S E R V I C E   N O T E

4957A Protocol Analyzer

Main board/A1 Assembly

Hi-Speed Option Retrofitting and VT100 Display

Figure 1.

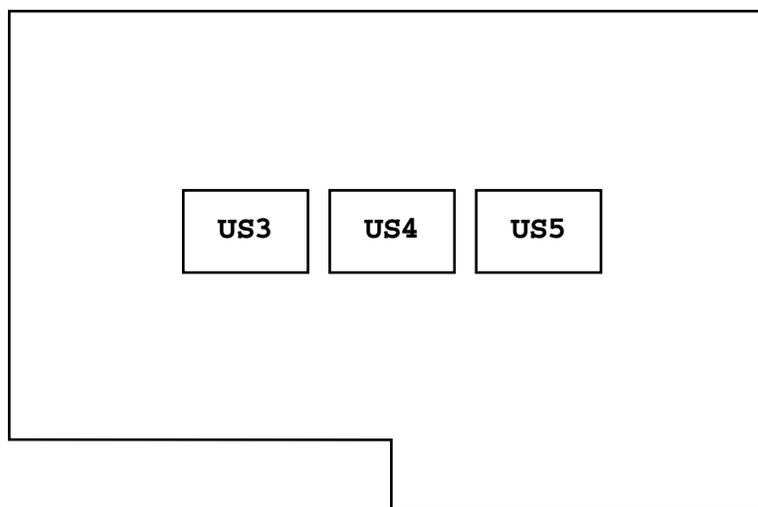
Situation:
The 4957A Option 001 allows the 4957A to capture data at a rate of 256Kbps. This ROM change will allow a standard instrument to be retrofitted with Option 001, 256Kbps data capturing capabilities.

Lift off the top cover, exposing the main board assembly. Using Figure 1, locate US3. Carefully remove the ROM from its socket, noting its orientation in the socket. Place the new ROM in the socket. Reassemble the instrument. At the Top Level menu, press <More> and <Load Appl>, the HS_Capture application should now be present in ROM. Go back to the main menu by pressing Exit twice. Go into the Self Test menu and run 5 to 10 self-test loops.

Solution/Action:
Order one of the above ROMs according to the version of the 4957A. If the instrument has an older ROM according to the above, then order three ROMs to effect the change.
